Zone A Pump Station and Transmission Main Project RFP Addendum #3

DATE ISSUED: 16 Feb 2023

The following changes, additions and/or deletions are hereby made a part of the Documents for the Construction of the PARADISE IRRIGATION DISTRICT ZONE A PUMP STATION AND TRANSMISSION MAIN PROJECT – JOB NUMBER 17-041 as fully and completely as if the same were fully set forth therein:

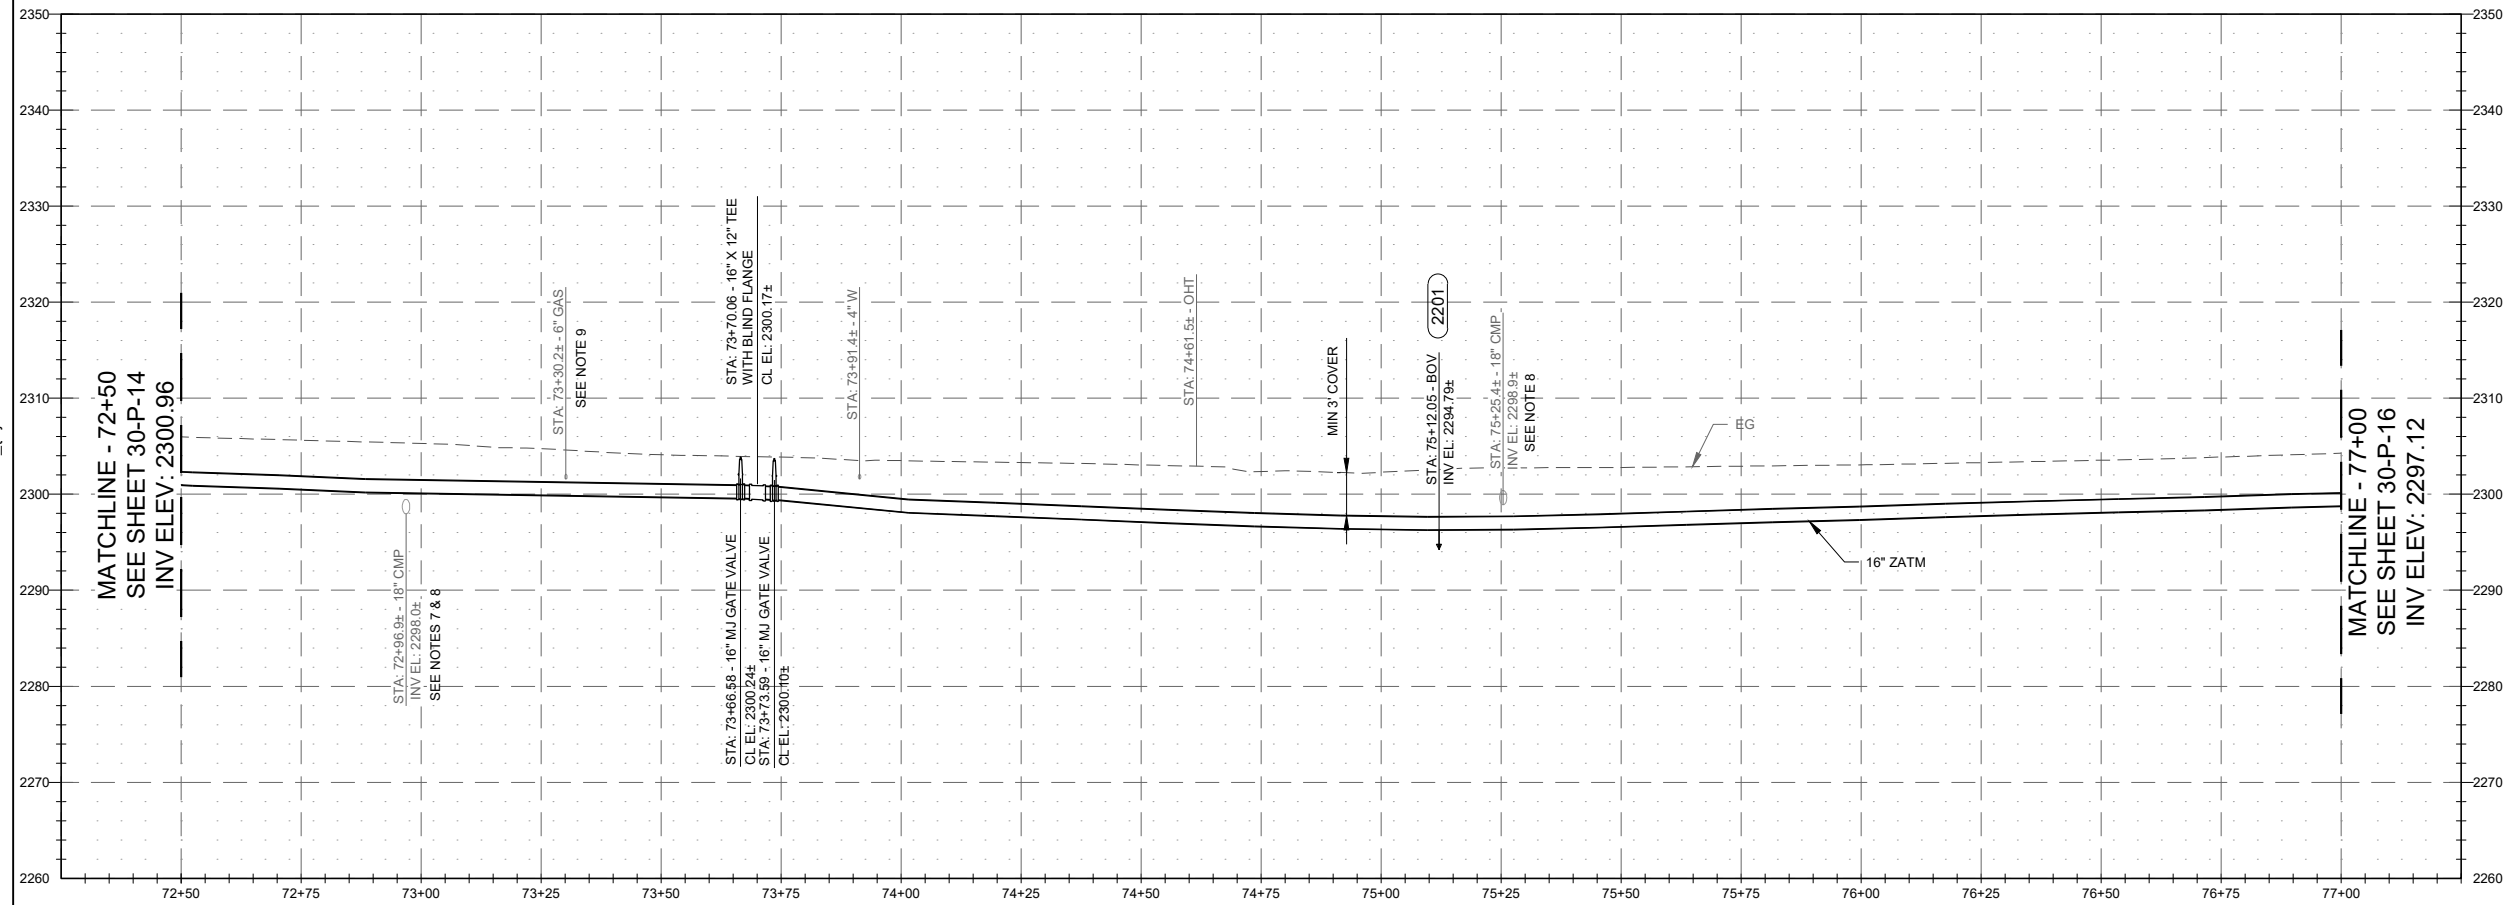
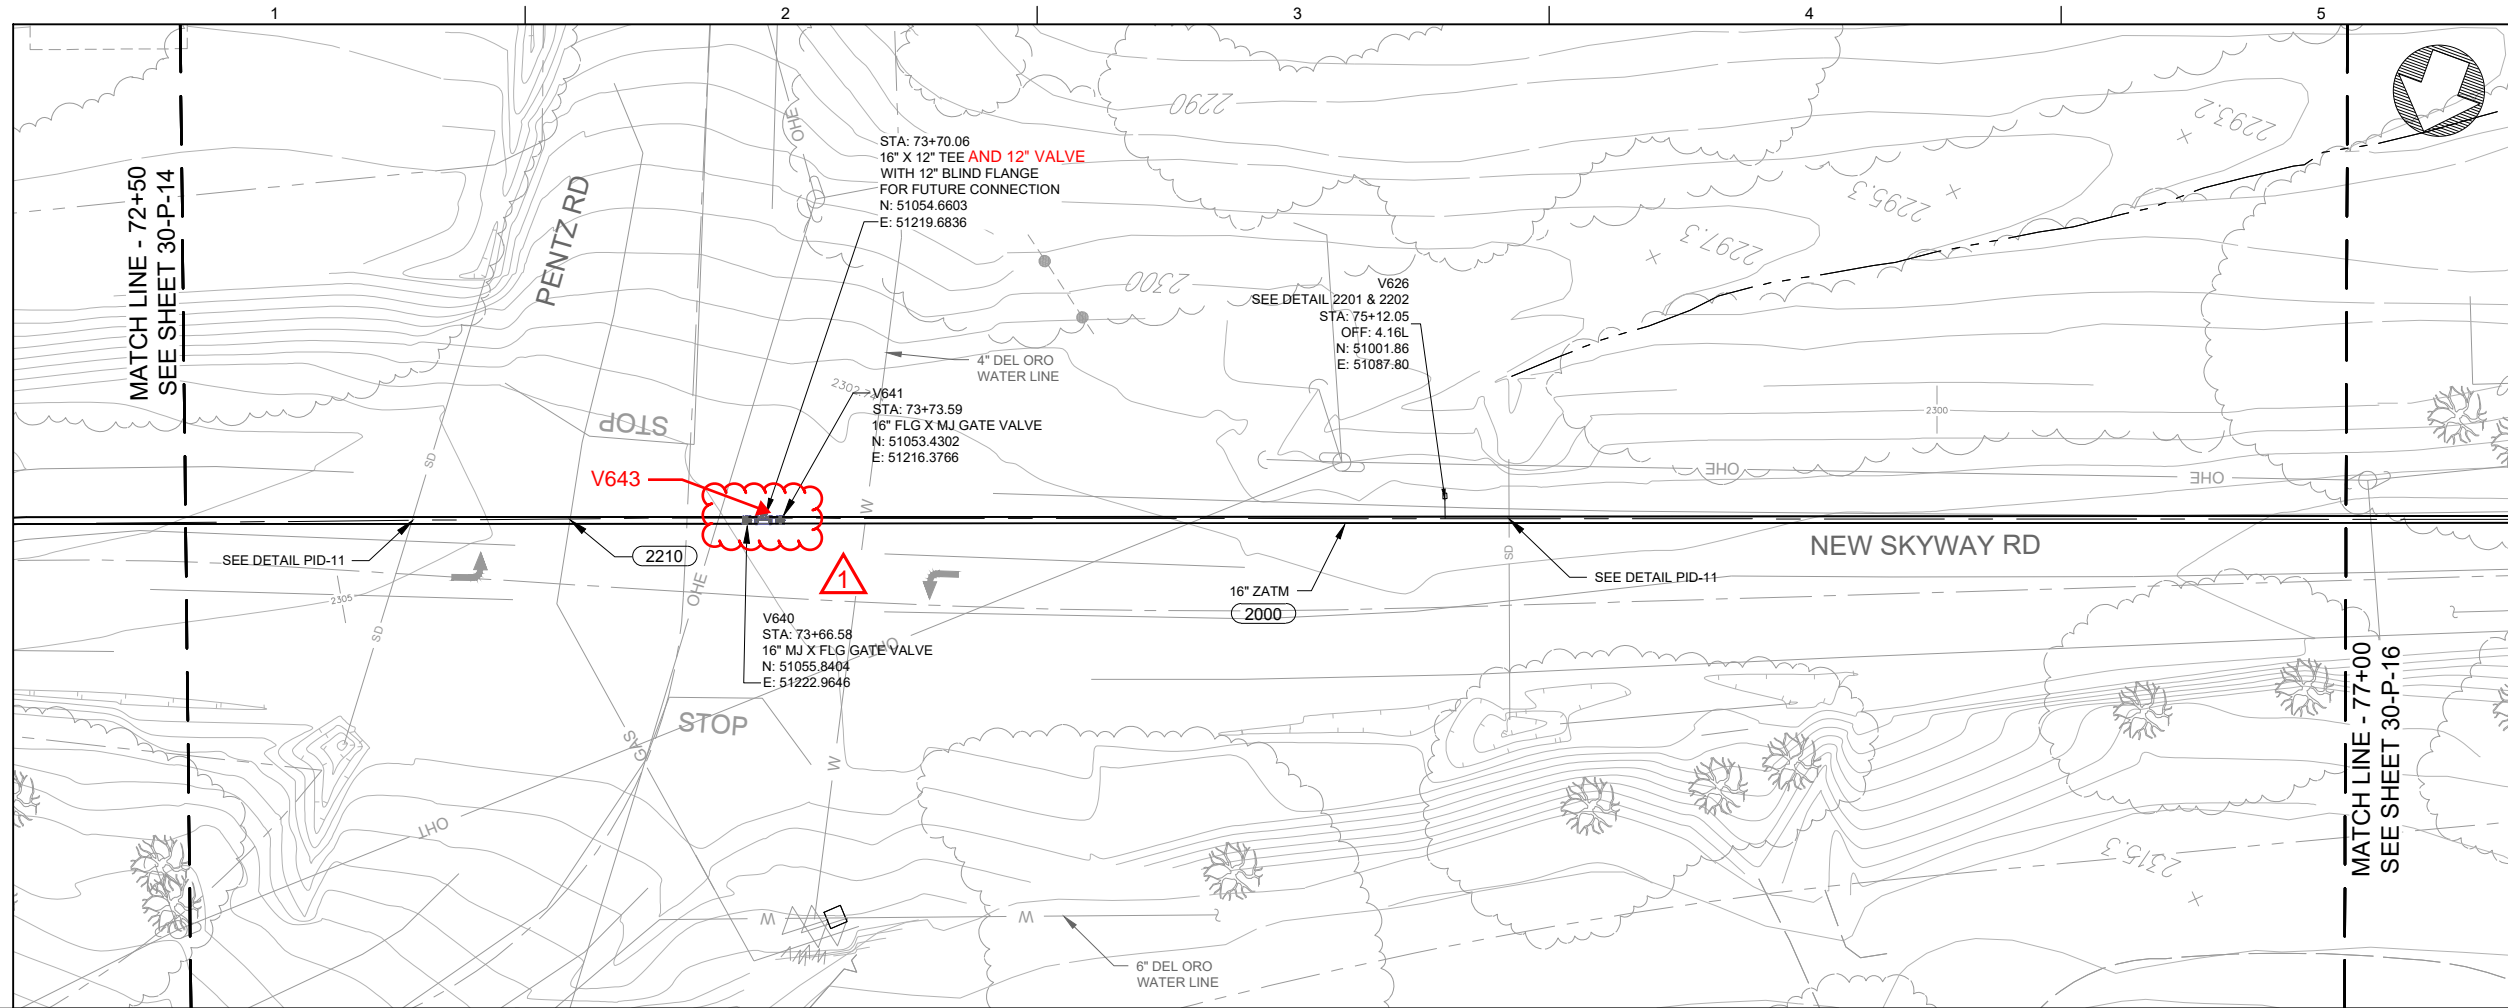
- 1. Yes, Contractor is to expect naturally occurring asbestos (NOA) in the Zone A Pump Station excavation area and the first section of the pipeline along Pine Needle Drive. See the notes added to the related drawing sheets.

- FOR CLEARANCE LESS THAN 12" SEE DETAIL 2210, DRAWING SD-4.
 - REFER TO GEOTECHNIAL REPORT FOR INFORMATION REGARDING HAZARDOUS MATERIALS THAT MAY BE ENCOUNTERED DURING DEMOLITION OF SERPENTINE ROCK.
